Item ID: D350-607-511 Accept *N900040100* Setup Start *NS1*
 Revision ID: Stop *NS2*
 Item Name: Quick Release Basket and Long Cargo Tube Mounting Provisions, Fits LH or RH
 Start Date: 9/3/2015 Start Qty: 1.00 *1* Cust Item ID:
 Required Date: 9/22/2015 Req'd Qty: 1.00 *1* Customer:
 Reference:

DART SERVICE INSTRUCTION

TO AMEND INSTALLATION INSTRUCTIONS D350-607-3 Rev.D,
INSTALLATION INSTRUCTIONS D350-607-4 Rev. C AND
INSTRUCTIONS FOR CONTINUED AIRWORTHINESS ICA-D350-607 REV. 6

FIGURE 1: INSTALLATION OF D4775-041 FWD STRUT

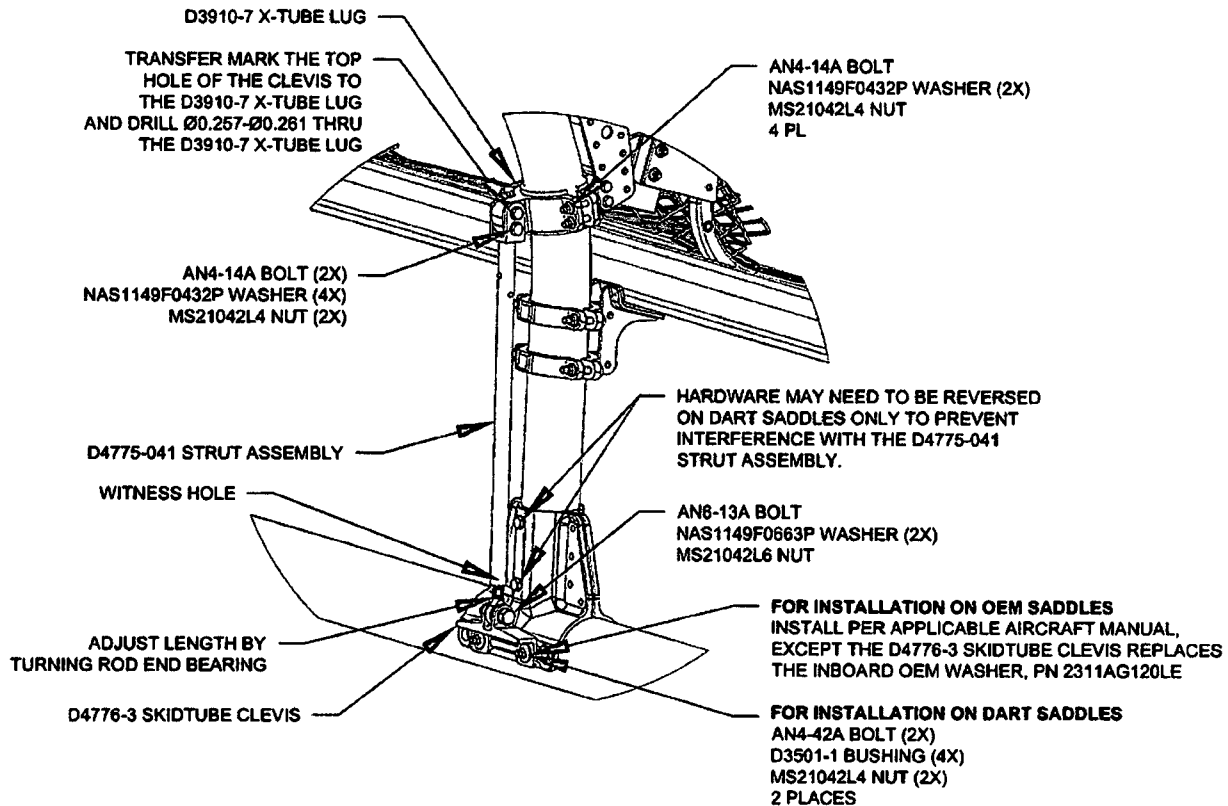
3.1 Substitute the Forward Lower D3910-5 X-Tube Lug with the D3910-7 X-Tube Lug as shown in Figure 1.

3.2 Install the forward D4775-041 Strut Assembly. Transfer mark from the upper hole on the clevis of the D4775-041 Strut Assembly to the D3910-7 X-tube Lug and drill thru the lug $\varnothing 0.257$ - $\varnothing 0.261$ as shown in Figure 1. Touch up chemical conversion coating per MIL-DTL-5541. Check the witness holes located at the bottom end of the D4775-041 Strut Assemblies to ensure that the thread from the rod end extends past the witness hole.
Torque MS21042L4/-4 nuts to 50-70 in-lbs (5.7-7.9 N-m). Torque MS21042L6/-6 nuts to 160-190 in-lbs (18.1-21.5 N-m).
